June 3, 1981  
FMY 81-87

Subject: Maine Yankee Fuel Storage Modification

Your letters, Reference (b) and (c) posed thirty-two questions relating to Maine Yankee's proposed spent fuel storage modifications.

FIGURE 1

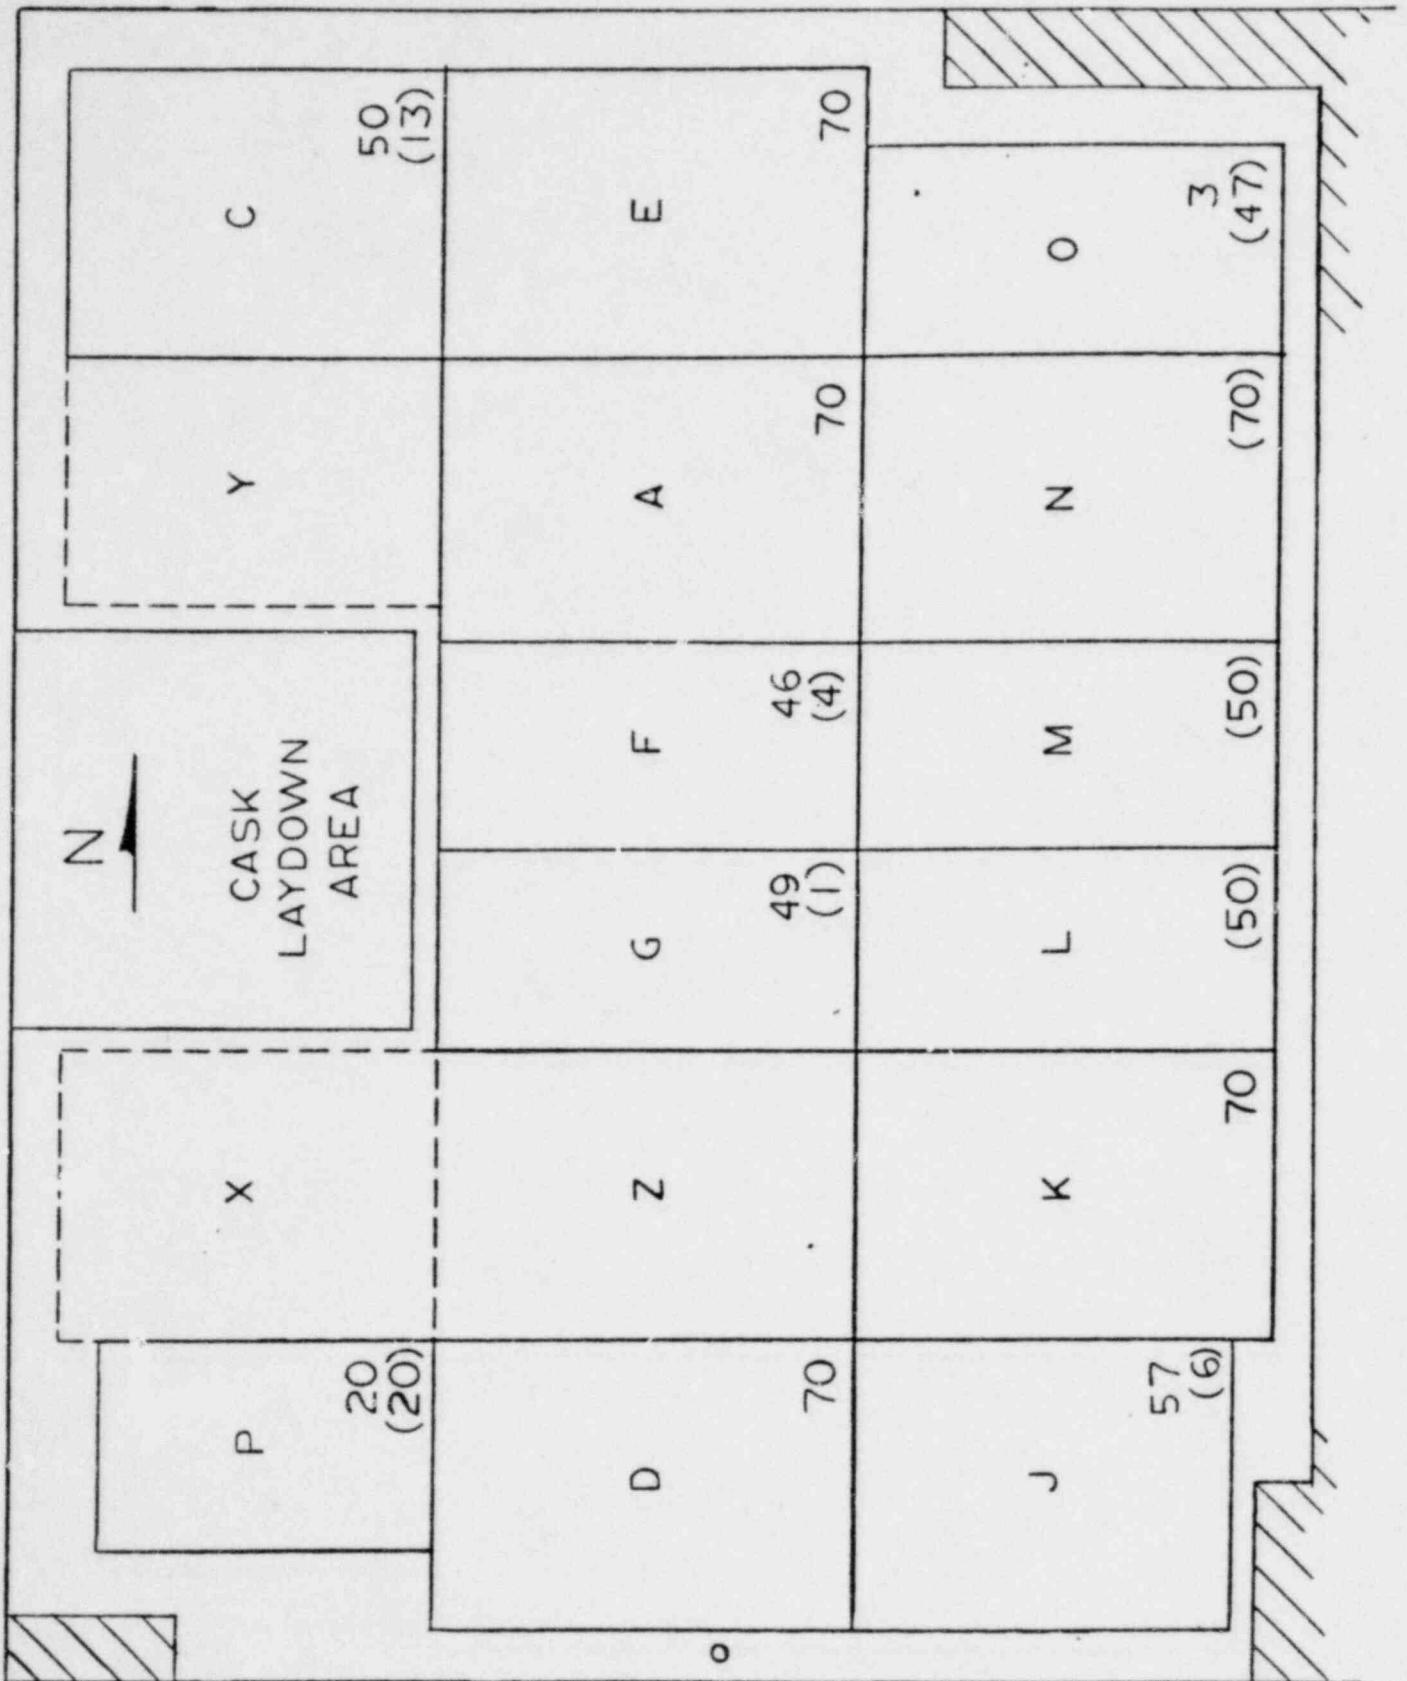
- a. With the aid of a drawing, describe the travel paths of the old and the new storage racks. Quantify the number of stored spent fuel assemblies that will be stored in the pool at the time reracking occurs.

Figure 1 shows the pool layout as is with the existing racks. Please note that Racks X, Y and Z are not installed yet; however, rack X is on site and will be placed into service should full core discharge be necessary. (Racks X, Y, and Z would constitute the final phase of the reracking approved via amendment 11 issued in 1975).

FIGURE 5

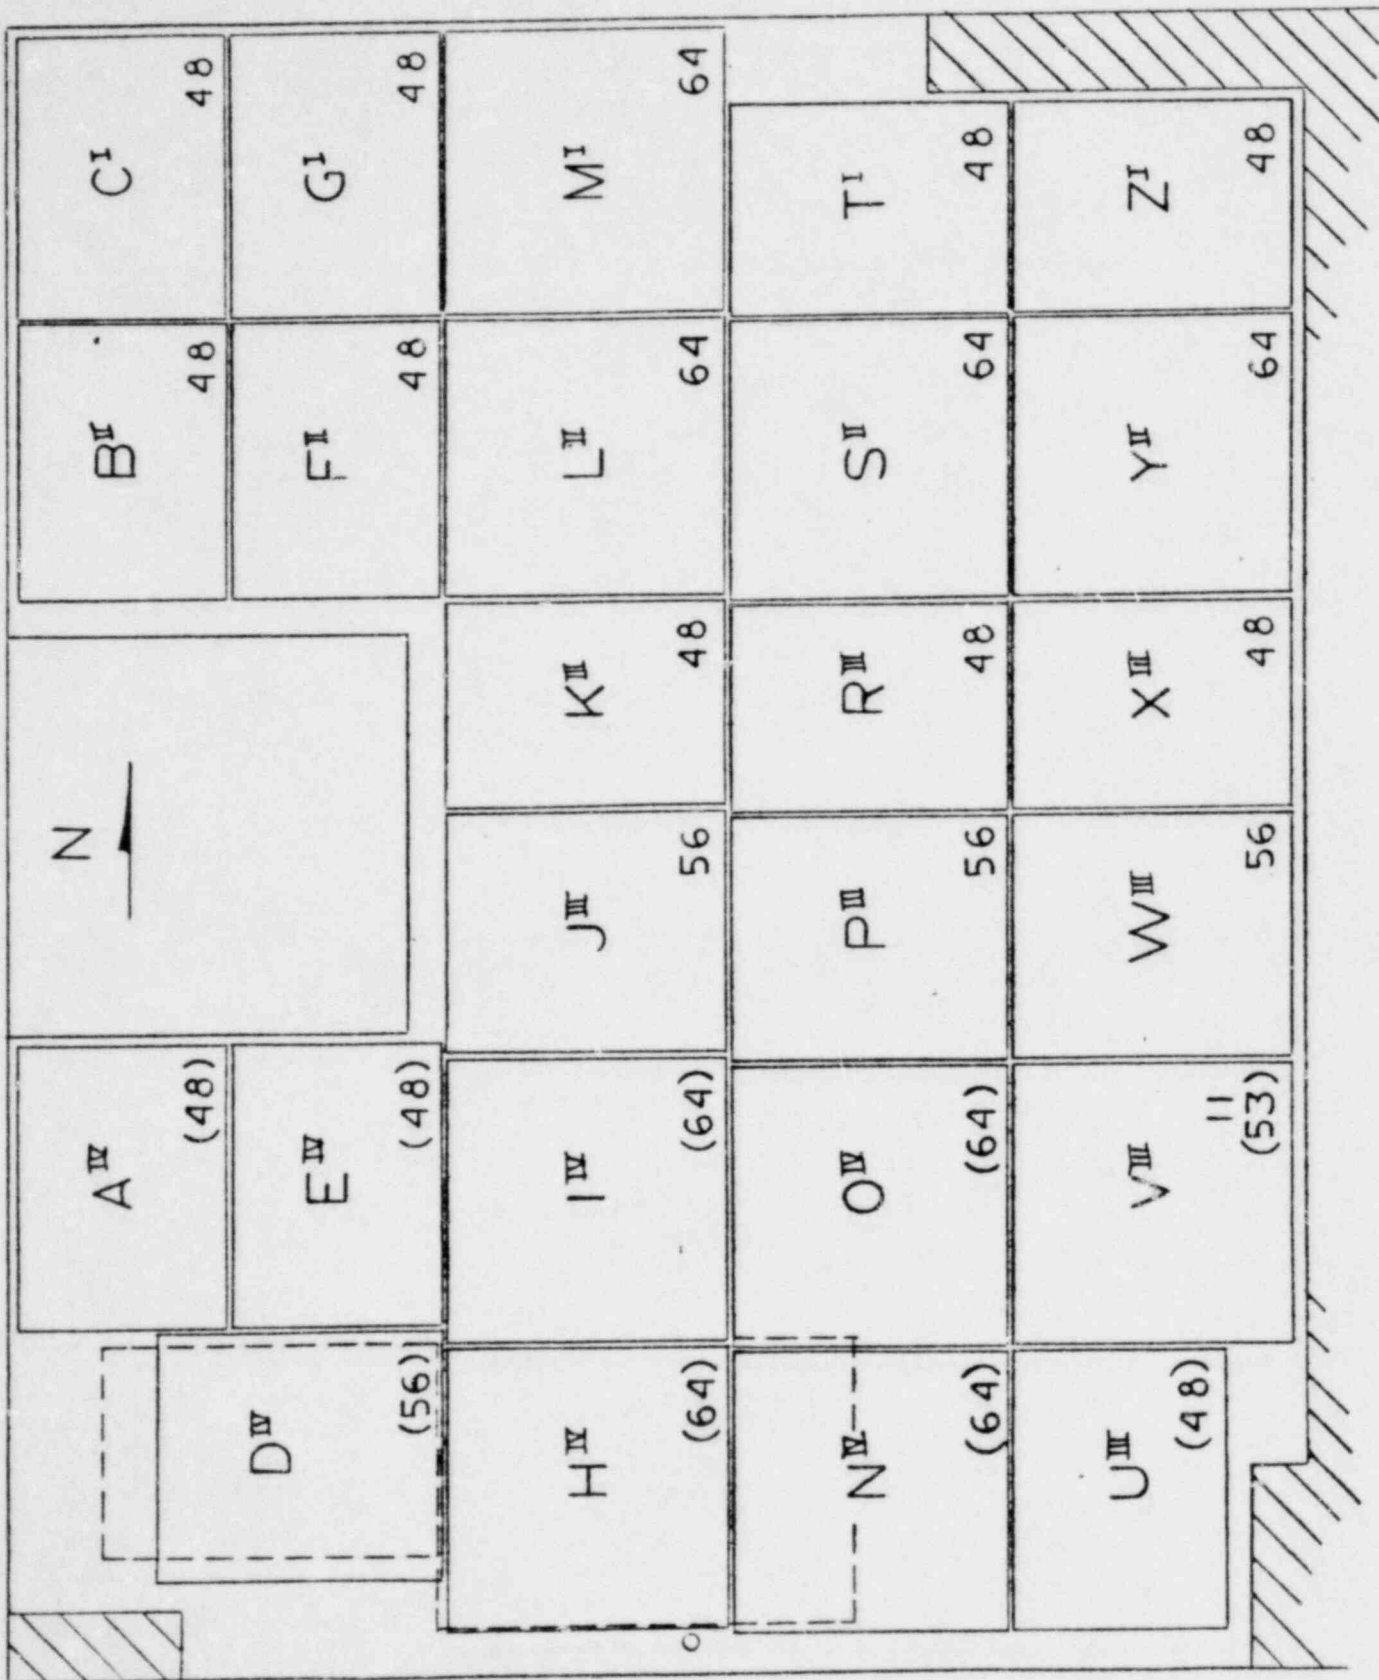
- b. With the aid of drawings describe the old and the new storage racks and their weights. Further, provide a description of the rigging that is interposed between the storage racks and the crane hook. Identify all cases where the proposed rigging does not meet the requirements set forth in Section 5.1.6(1) of NUREG-0612 "Control of Heavy Loads at Nuclear Power Plants," and explain why they are acceptable.

Phase IV (Figure 5) to be completed by February 1987

- a. Remove fuel from racks P and D.
- b. Remove racks P and D.
- c. Install new racks N<sup>IV</sup>, G<sup>IV</sup>, I<sup>IV</sup>, H<sup>IV</sup>, D<sup>IV</sup>, E<sup>IV</sup> and A<sup>IV</sup>.
- d. Dispose of racks D, P and X.

Inventory: 867 fuel assemblies and 509 empty storage spaces.

The weights of the new storage racks shown on Figure 5 are:

<u>Rack</u>	<u>Size</u>	<u>Weight</u>
L, M, H, I, S, O, N, Y, V	8x8	19,200
D, J, P, W	7x8	16,800
A, B, C, E, F, G K, R, T, U, X, Z	6x8	14,400
